DESCRIPTION

Aperia has replaced the current stainless steel tamper-resistant bolts with new grade 8 steel bolts (see Figure 1 and Table 1).

Figure 1. Updated bolts in teal

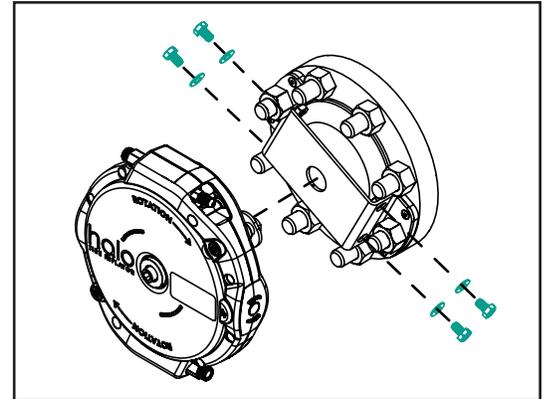
This is a running change, intended to prevent stripping at the Torx interface and improve fastener reliability.

The stainless steel bolts can be distinguished from the grade 8 bolts by looking at the surface finish and/or the presence of a nylon thread-locking patch. The stainless steel screws will have a more polished, shiny finish; while the grade 8 bolts will have a matte gray finish and a nylon thread-locking patch on the threads.

- Replace stainless steel bolts with the updated grade 8 bolts at the next preventative maintenance.
- Take care when loosening and tightening bolts to avoid stripping Torx interface.
- Tighten grade 8 bolts to 20 +/- 2 ft-lb and check for proper torque at each subsequent preventative maintenance.
